APPLICATION FOR ADMINSTRATIVE APPROVAL OF UNORTHODOX WELL LOCATION SAN JUAN 31-6 UNIT #6M WELL 30-039-26769

UNIT K, W/2 SECTION 1-30N-7W **RIO ARRIBA COUNTY, NEW MEXICO**

San Juan 31-6 Unit #6M Unit K, 1615' FSL & 2490' FWL

Offset Operators

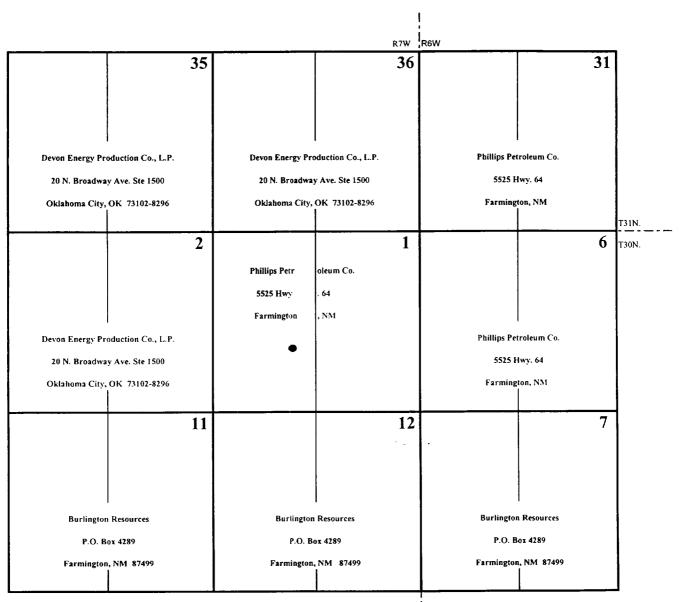
The submittal included a plat exhibiting offset operators. In an additional review of the plat it was noticed that Section 1 was not labeled as Phillips Petroleum Company being the operator even though it might be presumed as such. In addition, the header on the top of the plat had an error in the description. The header was labeled "T31N, R6W" whereas it should have been labeled "T30N, R7W". All other references to the description in the submittal are correct.

Because of the above omission and error, I have enclosed a revised plat in the event you would require or would prefer to have the plat with this information affixed. A copy of the enclosed revised plat along with a copy of this letter have also been mailed to the offset operators (Devon and Burlington), and to the NMOCD Aztec office.
